# ADA Site Review and Comments

Project: **Chinsegut Hill Retreat**  
22495 Chinsegut Hill Rd, Brooksville, FL 34601

Compliance Rating: **✘ Deficiencies**

Summary: **Accessible path slopes/surfaces, accessible parking space, ramps slope, emergency egress accessibility**

Figure 6: Proposed Accessible Parking Location

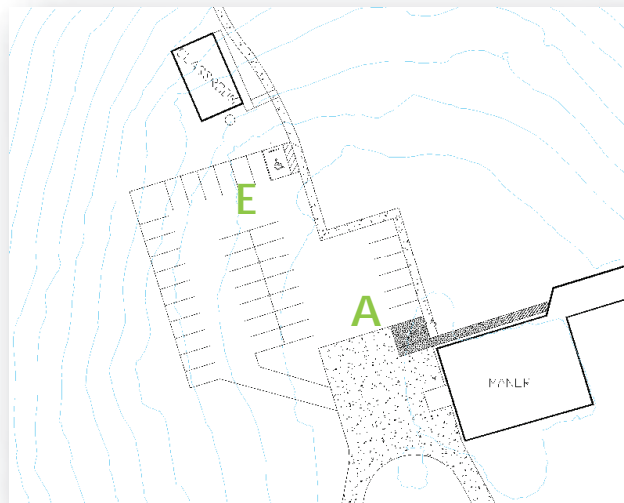
**✘** Only 1 of the 2 required accessible spaces are provided based on available parking spaces. While the parking spaces are not delineated in the grass parking area, it is understood these areas are routinely parked for events based on perimeter provided.

**Possible Solution:** Provide an additional ADA parking space in parking area 'E' near the entrance to the retreat area. Alternately, the space may be located next to the existing parking space 'A', or if vehicles are permitted or desired in the retreat area, near the accessible cabin 'K' or at the entry to Dining Hall 'Q'. If no other vehicles are permitted in the Retreat area during retreats, location E is the most compliant area.

Accessible parking spaces shall be paved (3000 psi concrete, 5" min. thickness is recommended on compacted soil) 12'-0" min. in width and 18'-0" in length designated with a 4" blue painted line on each side of the space with a 5'-0" wide aisle marked with 4" diagonal lines. Aisle and sidewalks shall be 4" thick concrete at a min. of 2500 psi. Spaces shall be marked with an accessible parking sign with violation notice meeting the state statues. (Figures 7 & 8)

Figure 11: Hernando County Accessible Parking Standards for Locations A & E

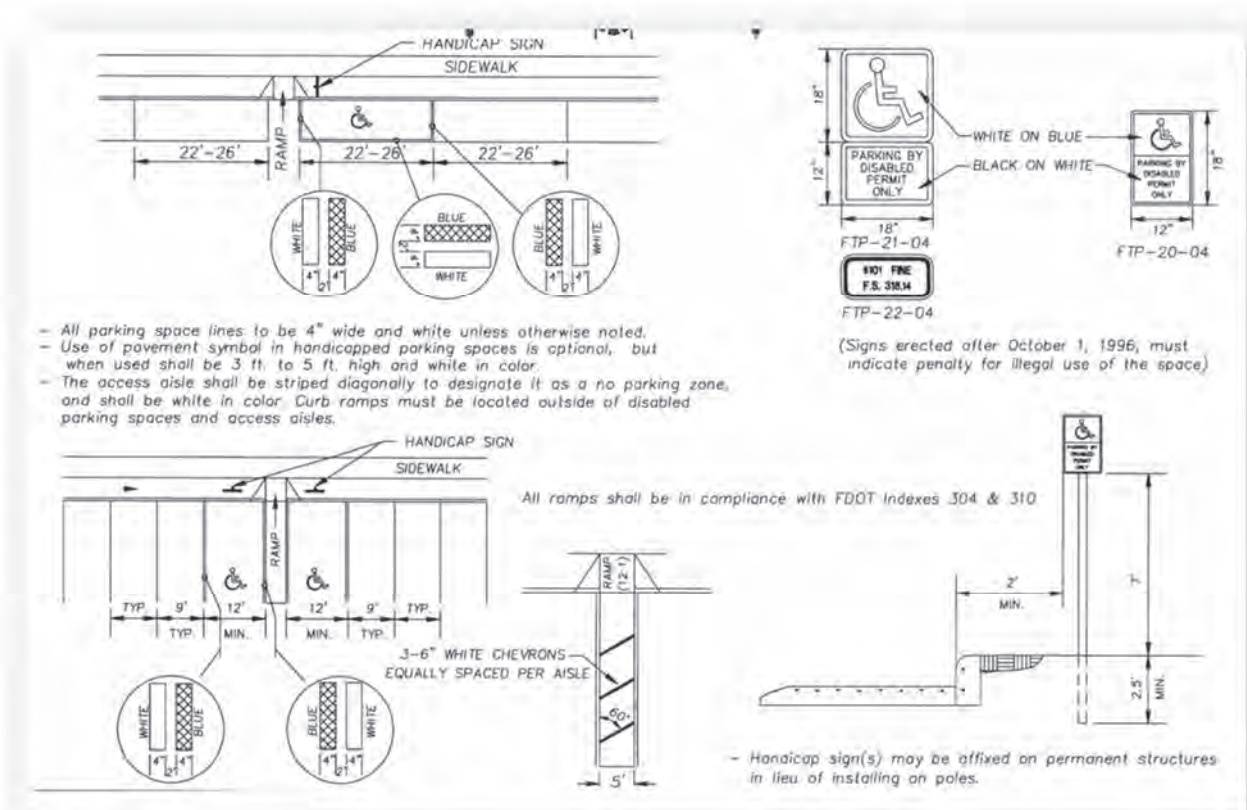
**✘** Pole Signage: **Improper Height: 53"** (<84" & >60" Abv Grade - FAC 502.6.1)  
**Improper Type: Missing Penalty and Statue #** (International symbol of accessibility and the caption "PARKING BY DISABLED PERMIT ONLY." Such a sign, erected after October 1, 1996, must indicate the penalty for illegal use of the space and state statute #. Face of sign to be located 24" min. from face of curb.

**Possible Solution:** Remount existing sign to taller pole so bottom of sign is placed between 60" and 84" above grade. Consider adding required parking striping to comply with Hernando County Standards. (Figure 11)

Figure 50: Threshold

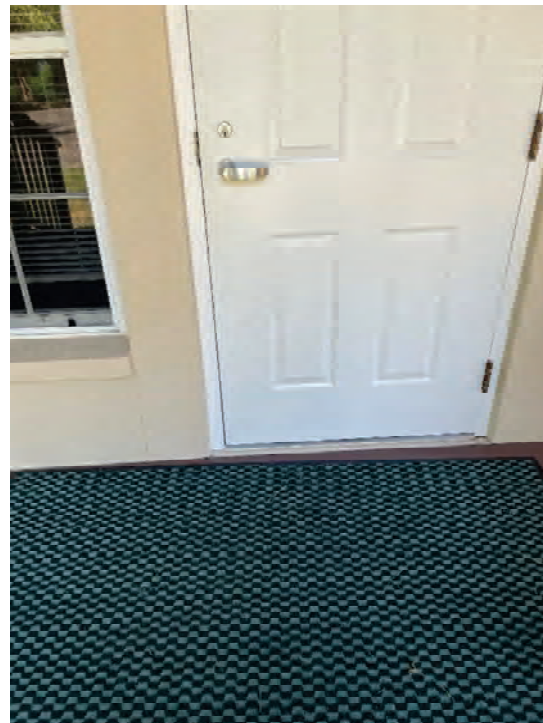
- +
 Width: 40.5" (Min. 36" Width Required) Building has an estimated occupant load of 6 negating the 44" egress requirement.  
 Length: 12'-6" (Max. 30' allowed)
- ✗
 Slopes: <2% Cross Slope & **9.4% Running Slope** (Max. <2% Cross Slope and <8% Running Slope allowed)
- +
 Landing: 60" x 60" <2% Slope (60" x 60" @ <2% Slope Allowed)
- ✗
 Guardrail: **38.25"** (Min. 42" Required)  
 Picket Spacing: **4-5/8"** (4" Max. allowed)  
 Handrail Dia: **Non-Compliant Design** (1.5" Dia. required FAC 505.6)  
 Handrail Extension: **4"** (12" min. Required FAC 505.10)  
 Handrail Clear: **Non-Compliant Design** (1.5" min. clearance required FAC 505.5)
- +
 Threshold: .25" change in elevation (.5" allowed with a .5" bevel otherwise .25" maximum allowed FAC 303.2) (*Figure 50*)

Figure 59: Accessible Path L-N

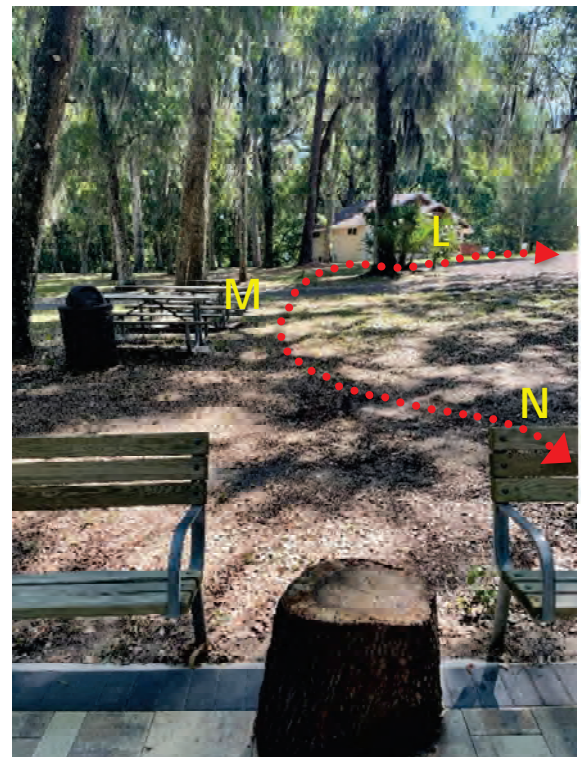
H-Q Accessible Path: No Accessible Path exists connecting public spaces on the site to include the Manor House (B), Parking Area (A&E), Classroom Cottage 2 (K), Fire Pit (O) and Dining Hall (Q). Excluded from this requirement are cottages 4-7 which are not required to be on an accessible route as these are not accessible lodging. (Figure 63)

Slopes: A-E: <2% Slope in the direction of travel  
 E-H: 3%-7% Slope in the direction of travel. (Requires arc in sidewalk path to reduce slope to <5%).  
 H-K: 4% Slope in the direction of travel  
 L-M-N: 4% Slope in the direction of travel  
 N-P-Q: 5% Slope in the direction of travel. (Requires arc in sidewalk path to reduce slope to <5%).

Possible Solution: Install a 5'-0" wide concrete sidewalk (min. 4" thick @ 2500 psi with control joints in 5'-0" increments) from the Manor House to Dining Hall (connecting points A, D, E, G, H, K, O and Q). Potential path indicated in (Figures 56-57). Path shall be no greater than 5% in slope in the direction of travel with a maximum 2% cross slope which is possible in

the general path shown in Figure 6. The sidewalk can be curved to fit with the dynamics of the land, reduce slope to less than 5%. prevent abrupt changes in direction requiring landings and avoid trees and tree roots. (Figures 57-61, 63)
